ACCESSION NBR: 8307050085 DOC. DATE: 83/06/15 NOTARIZED: NO DOCKET #  
 FACIL: 50-397 WPPSS Nuclear Project, Unit 2, Washington Public Power 05000397  
 AUTH. NAME AUTHOR AFFILIATION  
 BOUCHEY, G. D. Washington Public Power Supply System  
 RECIPIENT NAME RECIPIENT AFFILIATION  
 SCHWENCER, A. Licensing Branch 2

SUBJECT: Responds to NRC 830608 telecopy requesting clarification of three areas of util preservice insp program. Clarification of preservice insp of scram discharge vol sys encl.

Subject: NUCLEAR PROJECT NO. 2  
PSI SUMMARY REPORT CLARIFICATION

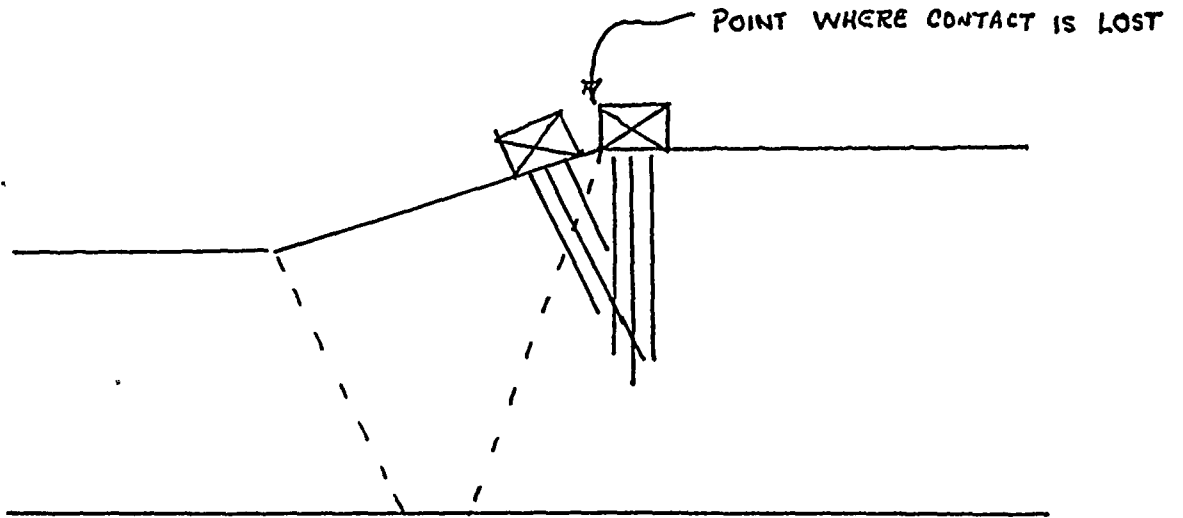
As described in the WNP-2 PSI Summary Report, contact between the ultrasonic transducer and the reactor pressure vessel wall was maintained approximately 75% of the time on the transition from the first to second shell course. This statement should not be construed to mean that the volume of material specified to be examined by ASME Section XI was not examined. To the contrary, the Supply System feels that a full code examination was performed. NES, Inc. performed this examination manually as described on pages 3, 4 and 5 of the WNP-2 PSI Summary Report. The LMT examination demonstrated that the mechanized equipment would produce results which are essentially the same as a manual examination. Regardless of whether a mechanized or manual examination is performed, a 100% examination is still achievable. This is because the examination is performed from the outside diameter of the vessel and from both directions, above and below the weld. Because of the slope, as shown below, the coverage overlaps.

The above illustration is for a  $0^{\circ}$  examination. For the  $45^{\circ}$  and  $60^{\circ}$  shear wave examinations, the transducer would not need to ride over this transition to gain full coverage of the required weld volume.
